MILITARY SPECIFICATION

WIND DIRECTION AND WIND SPEED INDICATING EQUIPMENT, TYPE B

Thia amendment forms a part of Military Specification MIL-W-15805F(SHIPS), dated 10 December 1962.

PAGE 1 of AMENDMENT-2

FIGURE 6. WIND DIRECTION AND SPEED INDICATOR, TYPE F.

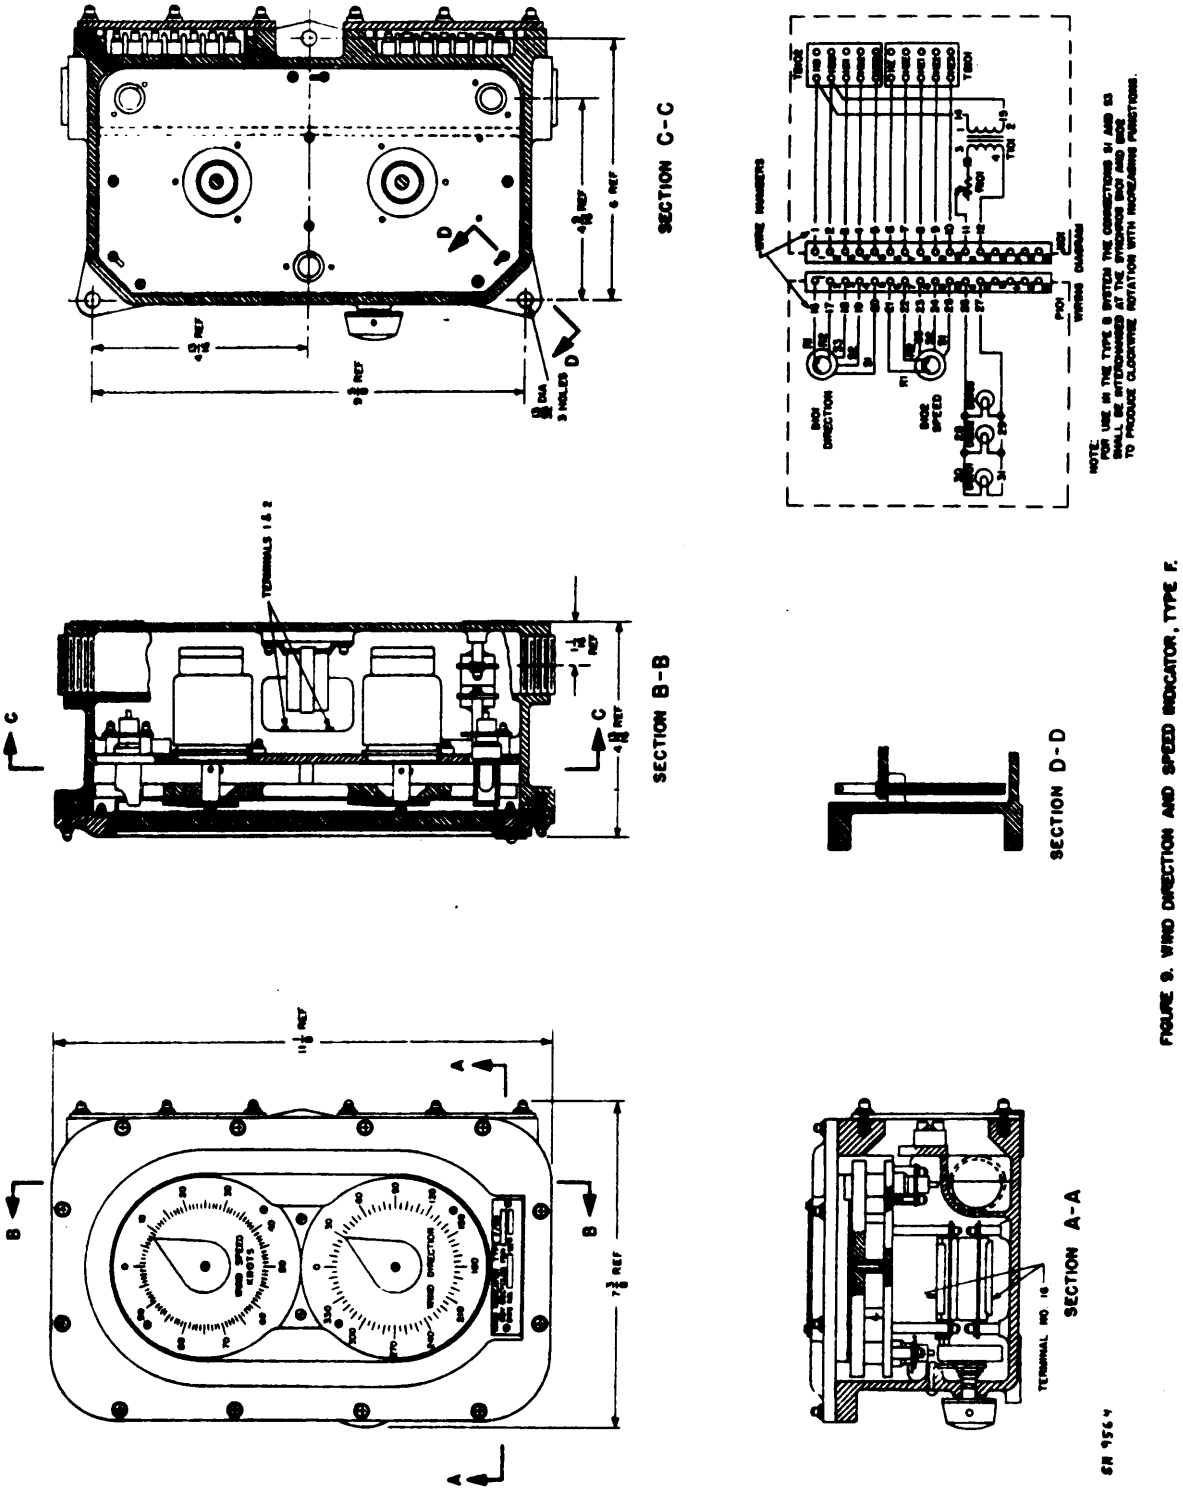
"3.4.3.2.2 Size. Type F indicators shall be as small and lightweight as practicable, but in no case shall dimensions and weight exceed the following:

Height - 11-1/8 Reference inches
Width - 7-3/8 Reference inches,
Depth - 4-13/16 Reference inches
Weight - 15 pounds
(Figure 9 is provided for guidance only)

Insert attached figure 9.
